INDIANA DEPARTMENT OF TRANSPORTATION

FIRST DRAFT MINUTES

July 17, 2014 Standards Committee Meeting

RE: First Draft Minutes for the July 17, 2014 Standards Committee Meeting

REVISION TO RECURRING SPECIAL PROVISIONS AND RECURRING PLAN DETAILS
 805-T-173d WIRELESS VEHICLE DETECTORS (WITH MARKUPS)

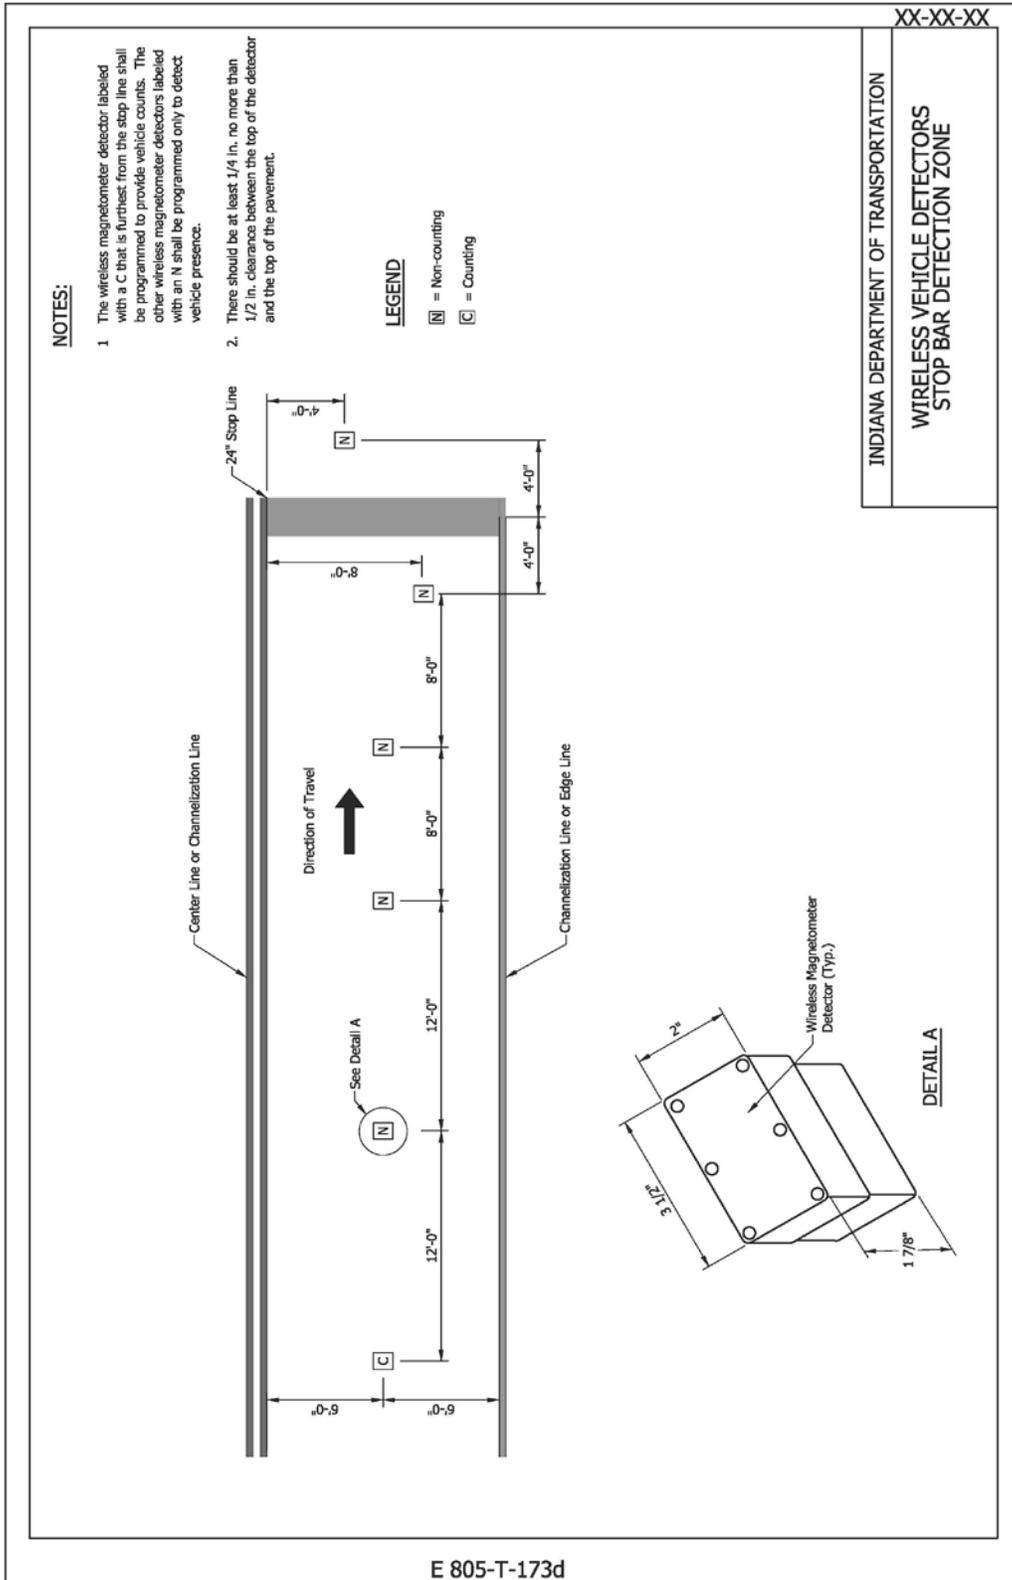
PROBLEM(S) ENCOUNTERED: Recurring Special Provision 805-T-173 and Recurring Plan Detail 805-173d regarding wireless vehicle detection refer to two types of wireless detectors, a type that is capable of counting vehicles and a type that is not. However, it turns out that the type that was thought to be incapable of counting vehicles actually can and the one that INDOT had been buying to count vehicles is more expensive and has extra features that aren't needed.

PROPOSED SOLUTION: In conjunction with updating the approved materials list for Traffic Signal and ITS Control Equipment, eliminate the type description in the pay item and clarify on the recurring plan detail that the detectors can be programmed to count vehicles.

1. The wireless magnetometer labeled with a C that is furthest from the stop line shall be programmed to provide vehicle counts. The other wireless magnetometer detectors labeled with an N shall be programmed only to detect vehicle presence.

This item was introduced and presented by Mr. Boruff who stated that there are some fundamental changes, as shown. Most of the changes proposed are editorial to correct language and descriptions.

Mr. Bruno offered that the figure in the drawings has been updated to match the proposed revisions.
